# **AMD-K6<sup>®</sup>**

## **Processor Revision Guide**

### **Model 7**

Publication # <b>21846</b> Rev: <b>H</b> Amendment/ <b>0</b> Issue Date: <b>June 1999</b>
----------------------------------------------------------------------------------------------

**Figure 1. AMD-K6<sup>®</sup> Processor Assertion of HLDA Due to Simultaneous  $\overline{\text{BOFF}}$ /HOLD Assertion**

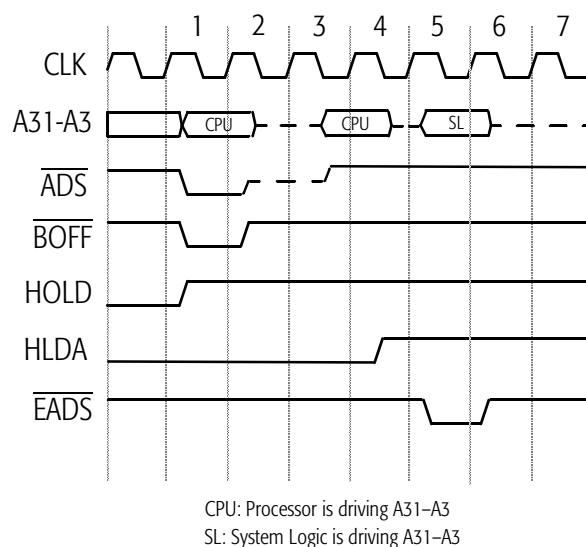
**Non-conformance.** If  $\overline{\text{BOFF}}$  and HOLD are sampled asserted on the same clock edge that negates  $\overline{\text{ADS}}$ , the processor asserts HLDA two clock edges after HOLD is sampled asserted.

**Potential Effect on System.** There are three potential effects of this erratum to consider:

- If the system logic asserts  $\overline{\text{BOFF}}$  for a duration of one clock, anticipates the assertion of HLDA in clock 3 (see Figure 1)—which is the normal specified operation—and drives the address bus and  $\overline{\text{EADS}}$  for an inquire cycle in clock 3, then the processor will not sample  $\overline{\text{EADS}}$  asserted. In addition, address bus contention will occur in clock 3.

- If the system logic asserts  $\overline{\text{BOFF}}$  for a duration of two clocks, anticipates the assertion of HLDA in clock 3, and drives the address bus and  $\overline{\text{EADS}}$  for an inquire cycle in clock 3, then the processor will not sample  $\overline{\text{EADS}}$  asserted. (No address bus contention occurs in this case.)

- If the system logic asserts  $\overline{\text{BOFF}}$  for a duration of one clock, anticipates the assertion of HLDA in clock 3, and drives the address bus and  $\overline{\text{EADS}}$  for an inquire cycle in clock 4, then address bus contention may occur in clock 4. (The processor will sample  $\overline{\text{EADS}}$  asserted in this case.)

If the processor does not sample  $\overline{\text{EADS}}$  asserted during an inquire cycle, cache/memory incoherency will occur. Address bus contention can affect the reliability of the processor and the system logic.

**Suggested Workaround.** The system logic must sample the assertion of HLDA before asserting  $\overline{\text{EADS}}$  and driving the address bus for an inquire cycle—as shown in clock 5 of Figure 1.

**Resolution Status.** AMD has determined that all Socket7 and Super7<sup>™</sup> chipsets operate as described in the aforementioned suggested workaround. Therefore, AMD has decided to defer the resolution of this erratum until deemed necessary.
